Planning Application 2022/3796 16-18 Oatlands Drive

We would like to strongly object to the above planning application, which seeks to replace 2 detached family homes with 2 blocks of 33 flats.

Photograph 1: Oatlands Drive before the construction of flats at 8-14 Oatlands Drive

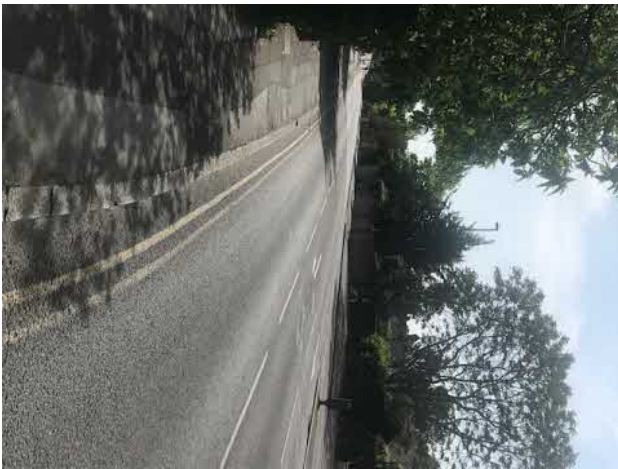
The inspector was incorrect when they said that the impact of 8-14 would not be too negative or out of keeping in the location. As anyone visiting site can see, it is extremely overbearing and out of place on both Oatlands Drive and on the path along the Engine River and pond.

These photographs before the commencement of the construction of the flats at 8-14 show the location in its long established appearance.

This is the context that all 3 of the proposed flatted developments at 16-18, 8-14, and 4-6 should be reviewed against, as in reality they are just phases of one large development, by the same developer, in one long continuous construction time. As 8 blocks of 111 flats, they would not fit sensitively within the location and would dramatically change its character.
